Plan Commission Meeting Date: July 14, 2014

Recommendation on Request by Gunderson Funeral Home, 5203 Monona Drive, for Approval of a Zoning Permit for Building Additions Totaling 3,552 SF and Parking Lot and Landscaping Alterations at this Location.

Re: Building & Parking Lot Addition – Gunderson Funeral Home - 6/30/14 Submittal
5203 Monona Drive, Monona, Wisconsin
Site Plan Review

ROOF MECHANICAL EQUIP SCREEN DETAIL

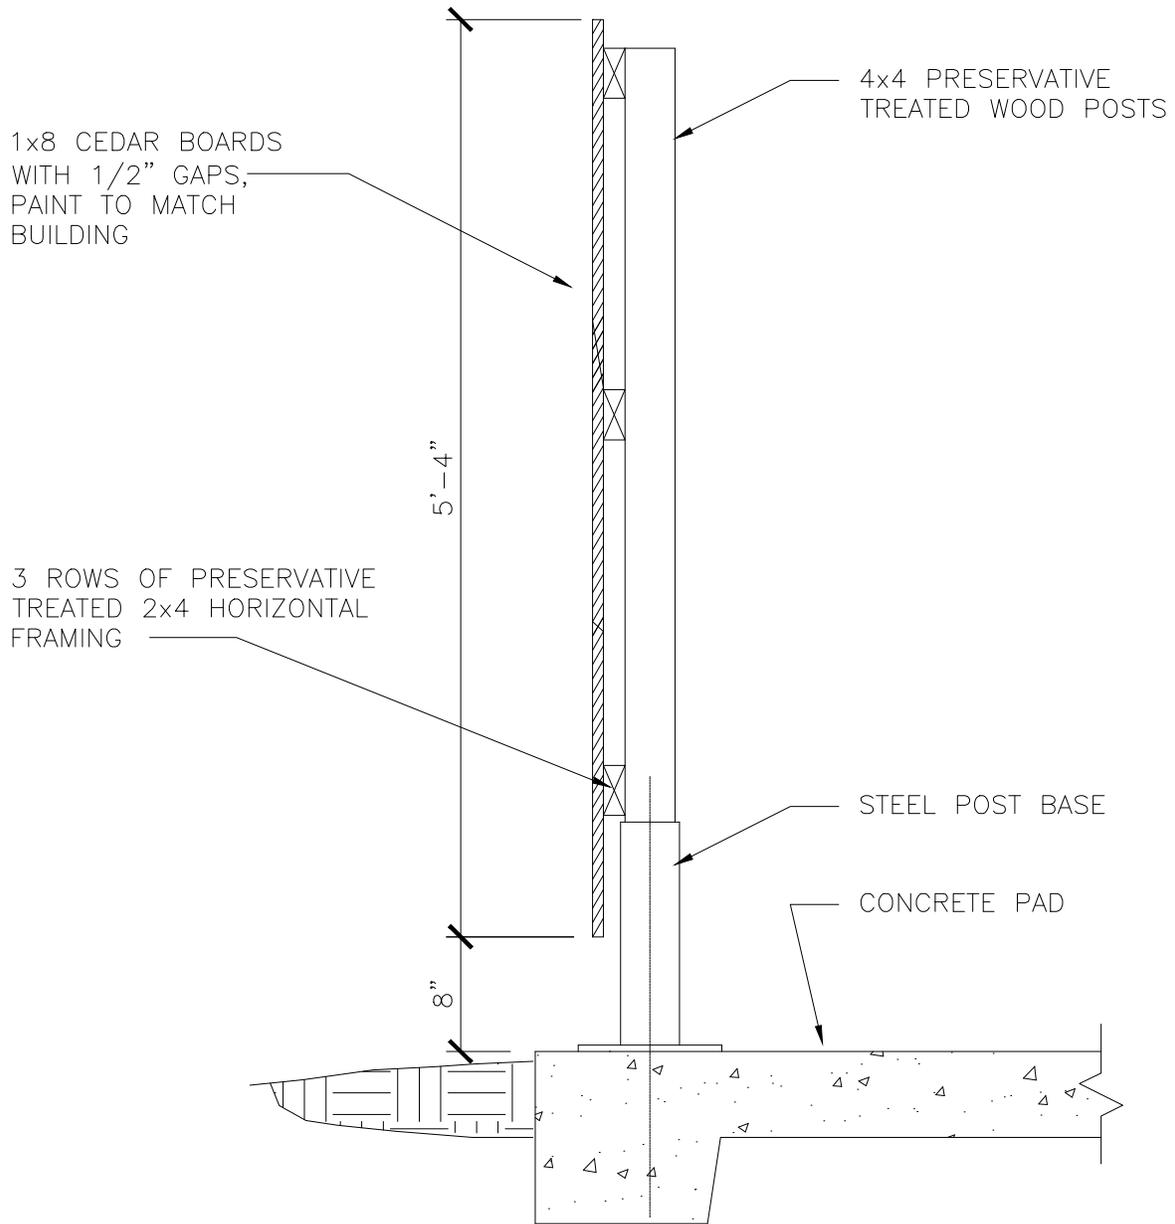
- o If mechanicals are located on the roof, they will need to be screened and the Commission will need to see detail on the screening/building material.

Roof Mechanical Equipment Screen Detail was included with the revised plan submittal. It shows screening sections to match the building materials and color.

DUMPSTER ENCLOSURE SECTION

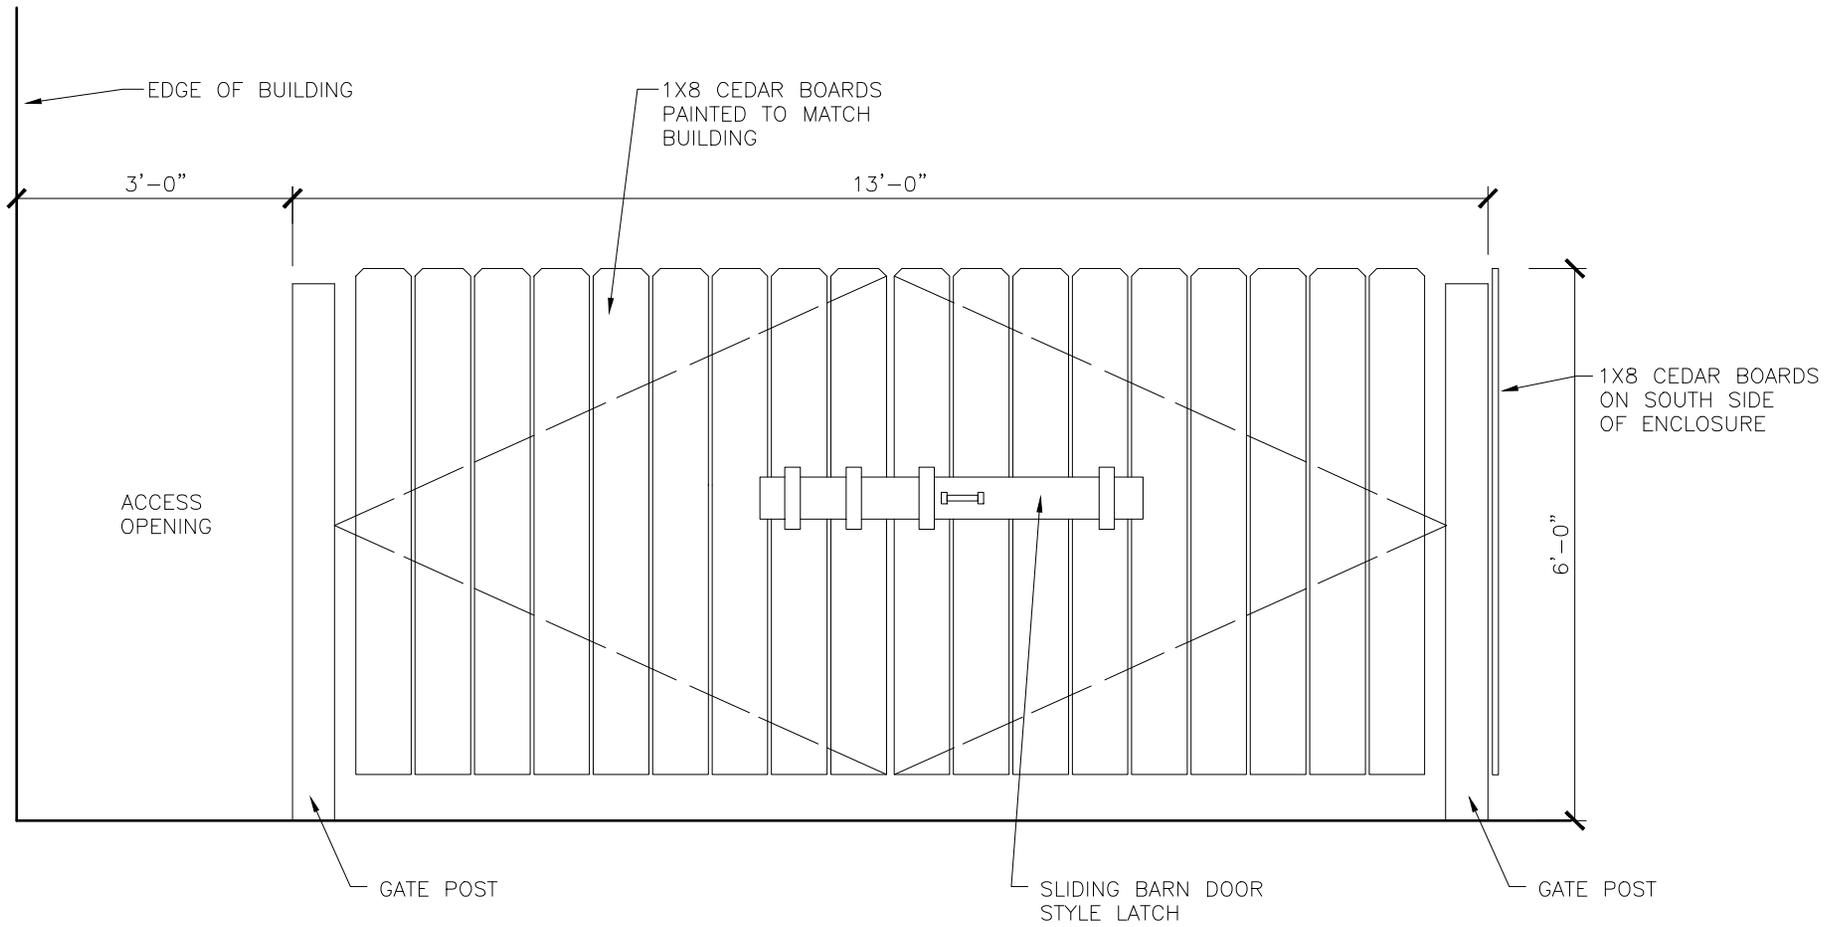
- Include the final location of the dumpster enclosure and elevations that show materials (that should match the existing building materials).
- Detail on the patio area (hardscape material).
- Landscaping Plan:
 - The Swamp White Oak on the east side of the property conflicts with an existing hydrant and street light. The revised plans should show the correct location of this tree.
 - Additional evergreens were requested to be added near the southwest corner of the property.
- Erosion control and stormwater management plans are required and will be reviewed by Darrin Pope at Vierbicher Associates.

A new 13'x6' trash enclosure is shown on the south side of the property and is well screened from view. The proposed materials include cedar boards painted to match the building with swing gates.

4 NORTH ELEVATION
A301 SCALE:

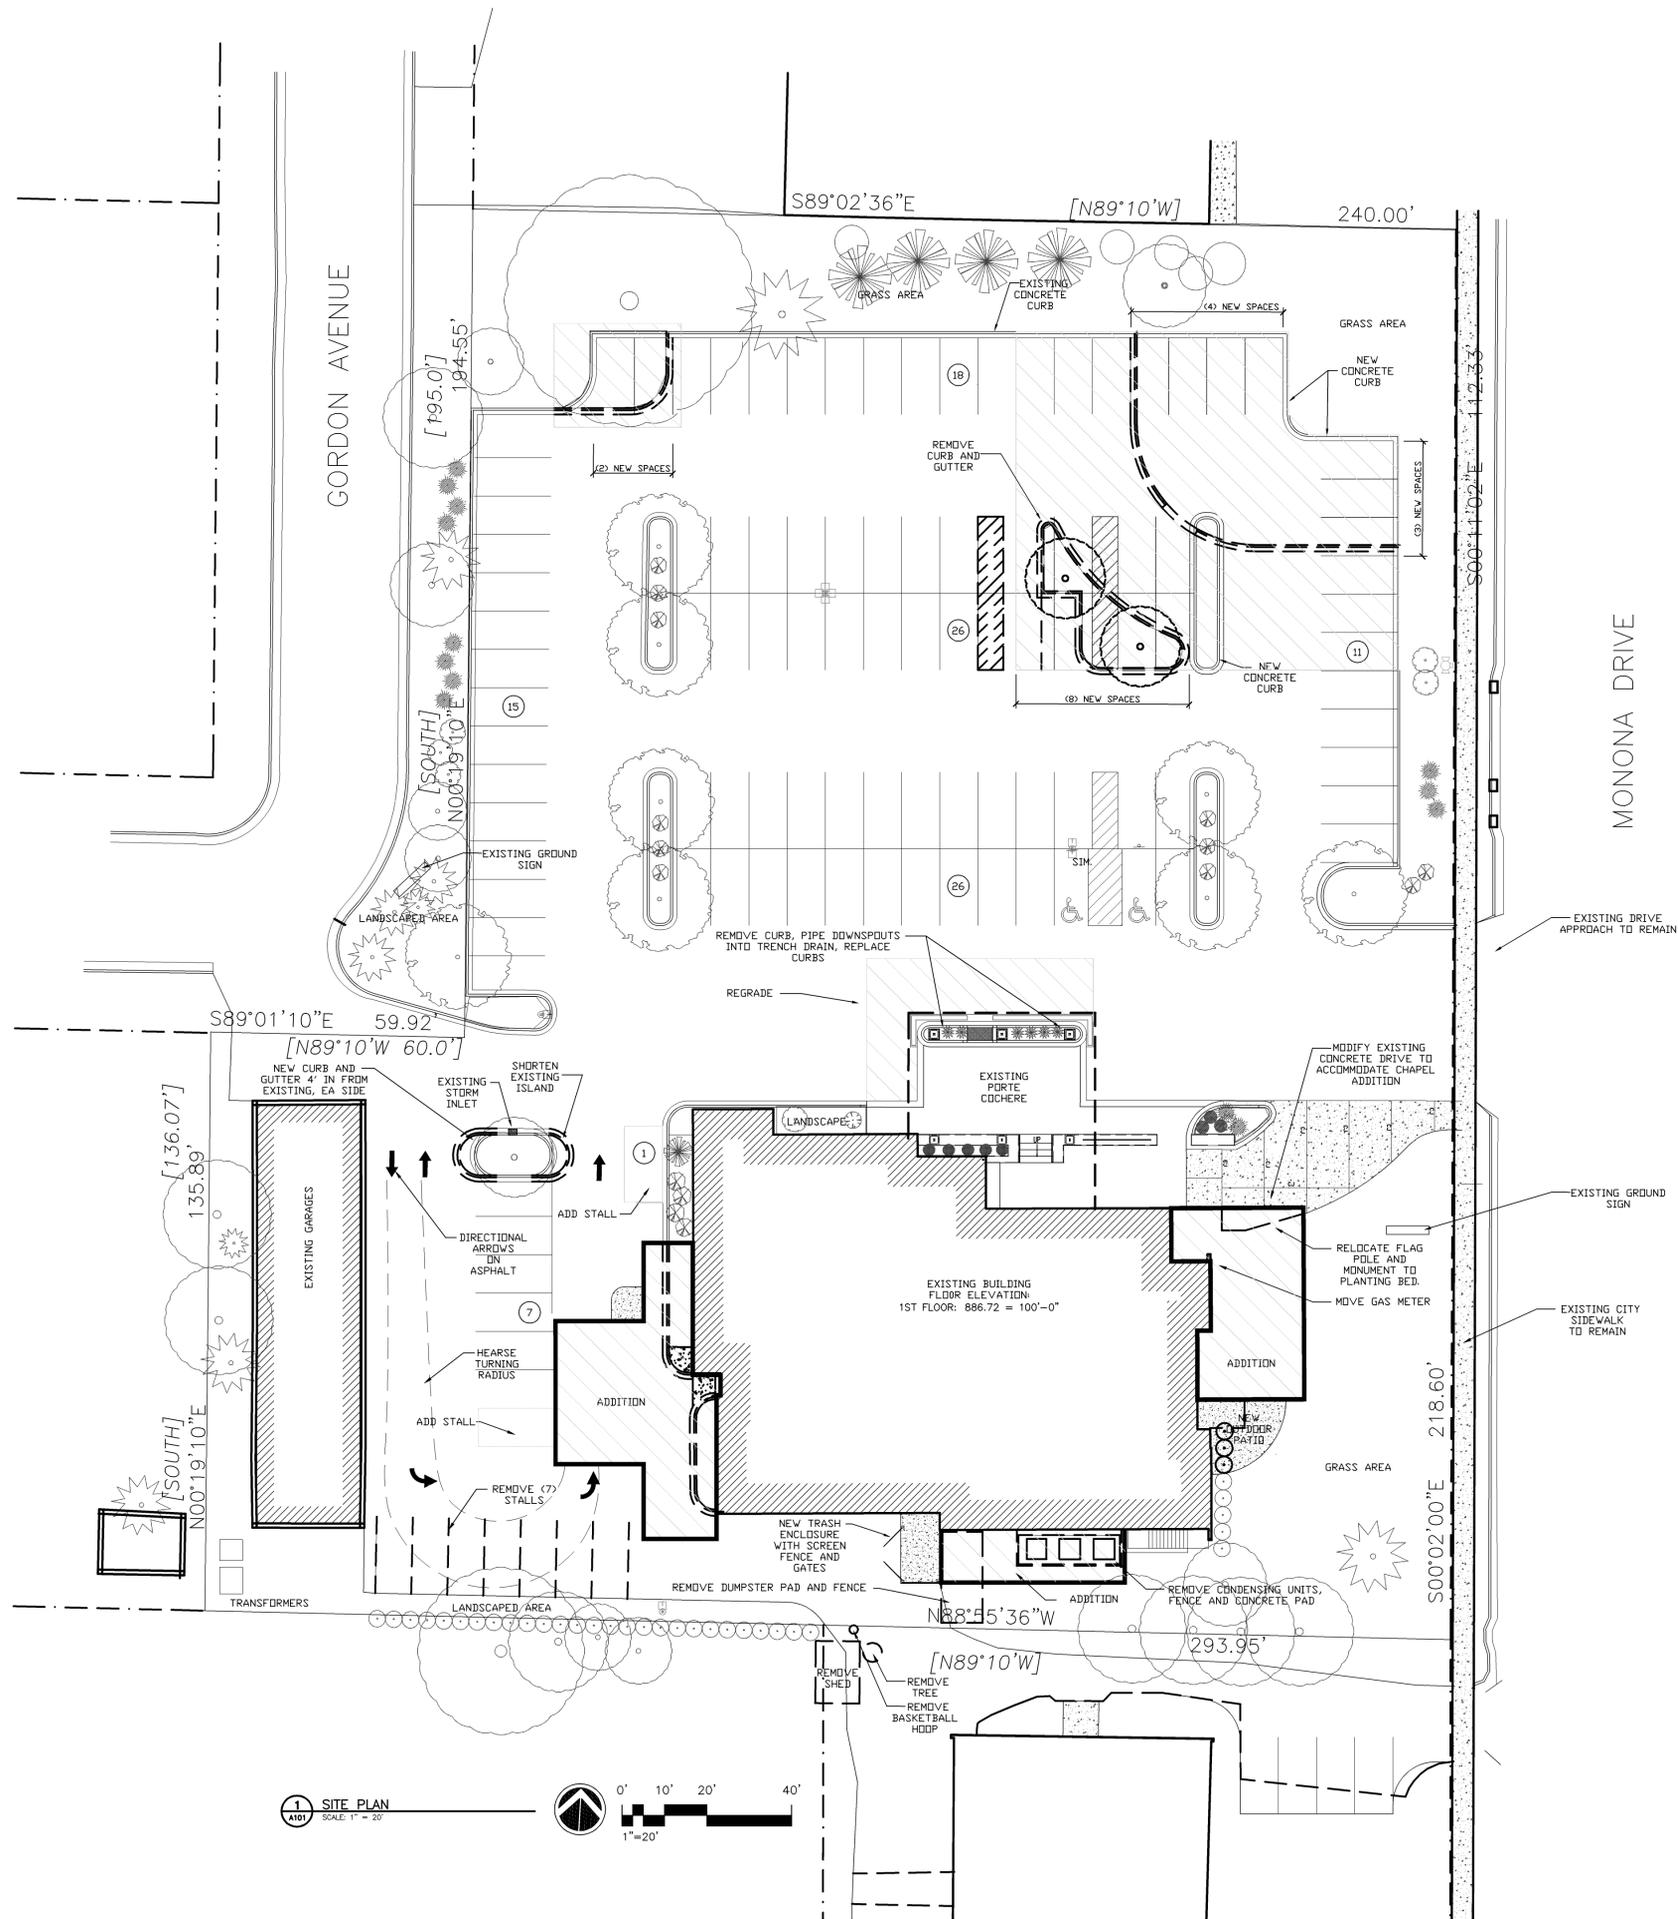
- Architecture/Building Elevations:
 - o West elevation building material: The Plan Commission discussed incorporating brick into the addition to tie in the addition more with the existing building.

- o East elevation massing: There was concern with a large flat mass on the Monona Drive elevation and loss of the existing step-back that works well at this location. Discussion included the potential addition of an overhang or step-back revision to this elevation.

- The chapel addition which faces Monona Drive includes horizontal brick on the base, EIFS, and stained glass windows. The overall height of this elevation was reduced since the 6/9/14 prehearing conference per the Plan Commission's request for better massing of the building. An eyebrow feature was also added to create more horizontal flow.
- The west building elevation was also revised since the 6/9/14 prehearing conference. Brick was added to the northern portion of the addition, while the southern portion of the addition remains EIFS. The height of the garage portion was also increased to better accommodate taller vehicles.
- The third addition on the south side of the building is proposed to be done in EIFS and includes three windows.

- Brick added at NW staff entrance
- New chapel overall height reduced along Monona Drive along with an eyebrow feature to create more horizontal flow
- West side garage roof raised to accommodate higher vehicles, but also provides a more interesting west side elevation
- Roof screens identified for roof top equipment (detail attached)

A101

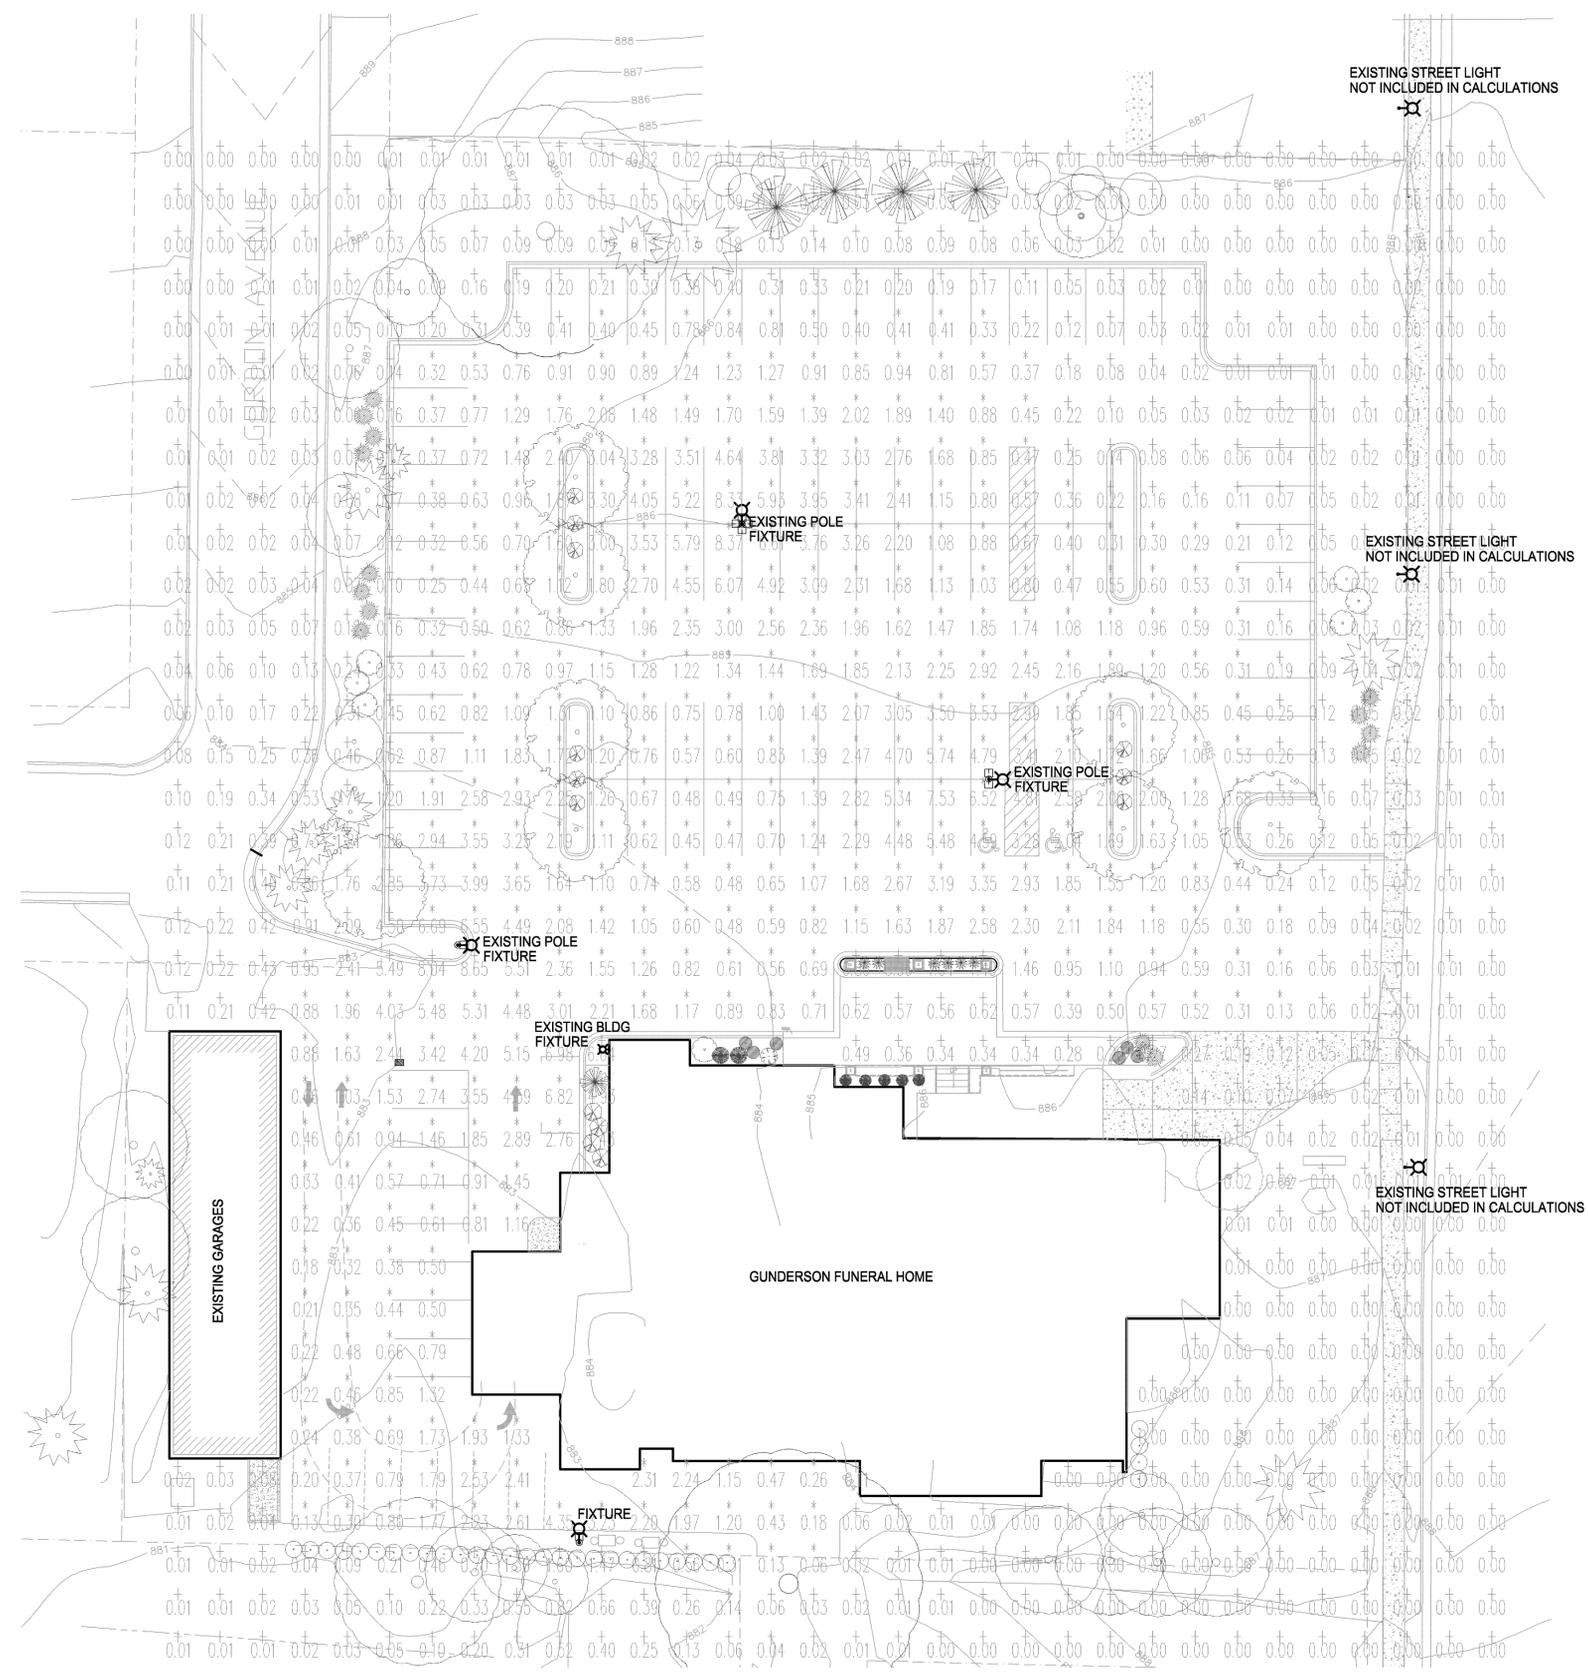
At the 6/9/14 prehearing conference, the Plan Commission requested that the applicants explore any options for reducing the amount of lost green space, perhaps through reducing parking stalls, or explore other ways to ensure water on the site is cleaned and controlled. The Commission also discussed the addition of inlet filters in the storm drains in the parking lot to offset negative effects from added impervious surface. Sheet C100 shows the addition of erosion control filter basins to the existing catch basin. Sheet A101 also shows that the landscaping island behind the building was retained.

- b. Review Comments:
 - i. The pervious and impervious areas, as well as the percent impervious area, for the
 - ii. Pavement dimensions and radii are not indicated on the Plans. Future submitted plans should include this information.

- iii. Parking spaces and drive aisles should be dimensioned on future submitted plans.
 - iv. Existing and any proposed handicap accessible parking spaces and access aisles should be shown on the plans.

- v. The proposed pavement structure should be shown on the plans and in compliance with the requirements of Section V.(a) of Appendix A - Site Design Standards for Parking, Landscaping and Lighting, Title 13 of the City's Code of Ordinances.

- vi. The elevations of the existing curb & gutter at which the proposed curb and gutter matches into should be shown on the plans.

- Retained parking lot island near west entrance to parking lot, though it has been shortened by 8 feet
- Located dumpster enclosure on south side of building (details attached)
- New outdoor patio south of the new chapel has been reduced in size (radius reduced by 3 feet). Patio will be concrete.
- Erosion control and storm water Management Plan
